Access Compliance Report

Public Rights-of-Way

(Curb Ramps)

Intersection ID: 10026082	Main Street: ENDHAVEN_LN	Cross Street: N/A	Location: NE
ADA ID: E7CBE9CD355E	Ramp Type: Perp	Initial Pass/Fail: Pass	Overall Compliance: No
			Severity Score: 0.25

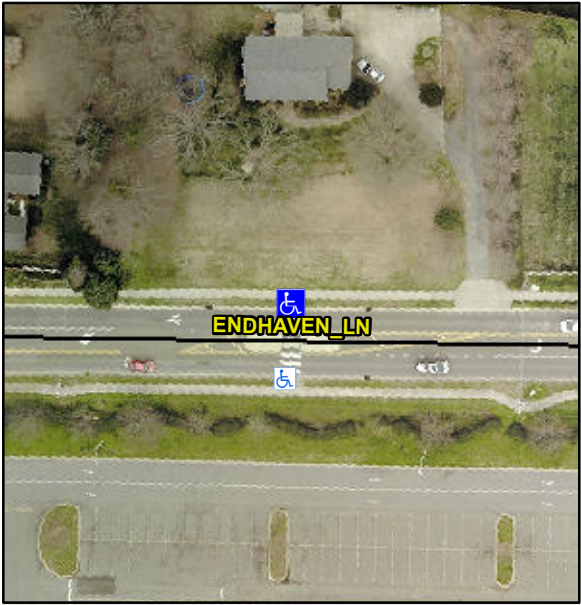
Codes/Mitigation Info/Possible Solution		Field Measurements/Component Compliance					
	Possible Solutions:						
	Remove & Replace Entire Ramp.						
	Surveyor Notes:						
	N/A						
	PROW/ADA:						
	Not Found, R304.5.3, R305.2						
Street 1 Name	ENDHAVEN LN						
Stop Condition-Street 2	None						
Street 2 Name	N/A						
Stop Condition-Street 1	N/A						
Total Cost:		\$	1850.00

Compliance	Description	Data	Compliance	Description	Data
N/A	Ramp Length (in)	48.0	Yes	Ramp Slope (%)	5.2
Yes	Ramp Width (in)	53.0	No	Ramp XSlope (%)	2.4
N/A	Flare Type LT	Sloped	N/A	Flare Type RT	N/A
N/A	Flare Slope LT (%)	0.7	Yes	Flare Slope RT (%)	5.2
N/A	Flare Traversable LT?	Yes	N/A	Flare Traversable RT?	Yes
Yes	Landing Length (in)	60.0	Yes	DWS Provided?	Yes
Yes	Landing Width (in)	60.0	Yes	DWS Contrast?	Yes
Yes	Landing Slope (%)	1.5	Yes	DWS Length (in)	24.0
Yes	Landing X Slope (%)	0.9	Yes	DWS Full Width?	Yes
N/A	Landing Curb? (Y/N)	No	No	DWS Offset (in)	3.0
N/A	Shared Landing?	No			
Yes	Gutter Ponding?	No	Yes	Gutter Slope (%)	2.2
Yes	Gutter Lip Ht (in)	0.0	Yes	Gutter X Slope (%)	0.5
N/A	Painted X Walk1?	Yes	N/A	Painted X Walk2?	N/A
	X Walk 1 Direction	To SW		X Walk 2 Direction	N/A
N/A	X Walk 1 Width (in)	121.0	N/A	X Walk 2 Width (in)	N/A
	X Walk 1 Slope (%)	0.8		X Walk 2 Slope (%)	N/A
	X Walk 1 X Slope (%)	0.1		X Walk 2 X Slope (%)	N/A
